Conceptual Master Plan Site Section with Building Heights

Questions and Answers

LBNL at GGF is an ambitious initiative that will change the character of the waterfront in Albany and Berkeley. We appreciate the interest and concern by everyone who wants to know more about the future plans for the property. The following are your requests for more information along with our responses. We greatly appreciate your inquiries.

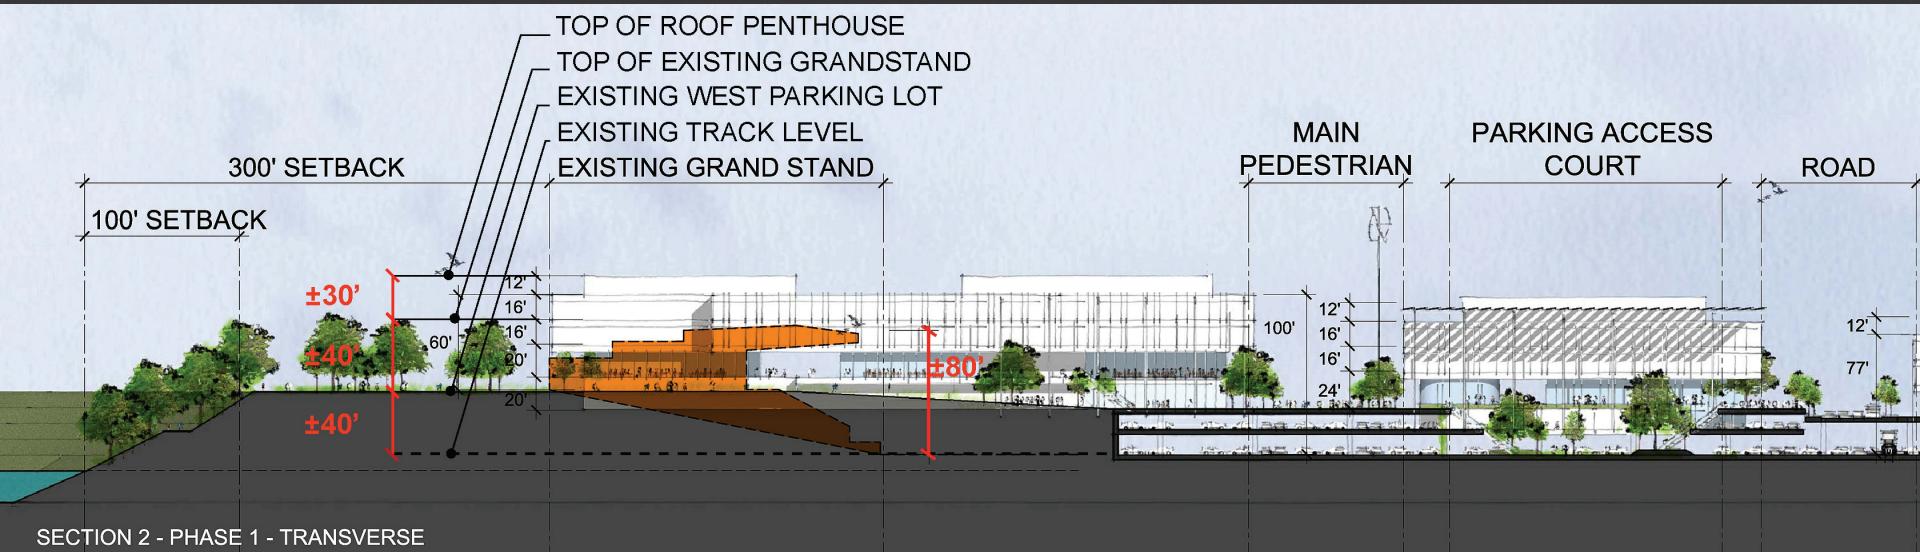
Q. As a homeowner who lives on Albany hill with a view of both the track and the bay, I am naturally very interested in the proposed LBNL development in Albany. We've read that the proposed buildings would be as tall as a "seven story condo." It would be helpful for my neighbors and me to get some perspective of what this means in relation to existing structures at the track.

How high is the top of the grandstand is above the track/infield level?

How high is the roof of the green wooden television platform at the north end of the track?

How high is the parking lot on the hill on the West side of the grandstand from track level?

How high is the top of the grandstand from the parking lot on the hill?

A. The [attached drawing](#) is a "section" cut across the site looking North with the Bay on the left side and I-80 to the right. From this vantage point the setback of the buildings from the waterfront is approximately 300'.

- 1) Top of the grandstands is about 80' above the existing track level.
- 2) Top of the green TV tower at the north end of the site is 70'.
- 3) West side parking lot is about 40' above the existing track.
- 4) The grandstand is 40' above the west side parking lot.

An additional scale reference is the highway GGF sign at the south end of the site. This is 93' high.

Note: The proposed LBNL lab buildings will be about 90-105' above grade or about 25' higher than the existing grandstand roof. Here's why.

Lab buildings require more space between floors (f-t-f) than regular office buildings because of extensive equipment and mechanical systems. We anticipate that the labs will be 20' f-t-f on the first floor and 16' f-t-f on upper levels. Buildings also require mechanical equipment screens and an elevator penthouse. These add another 12'. Buildings will be built over a two level parking podium which will add another 25'.

Therefore a three-story lab building will be $25'+20'+16'+16'+12'=89'$. Similarly, a four-story building on the podium will be $25'+20'+16'+16'+16'+12'+25'=105'$. All heights may be adjusted a few feet for the final grading of the site.

Note: A seven-story condo with 13' floor-to-floor heights would be 91' tall.
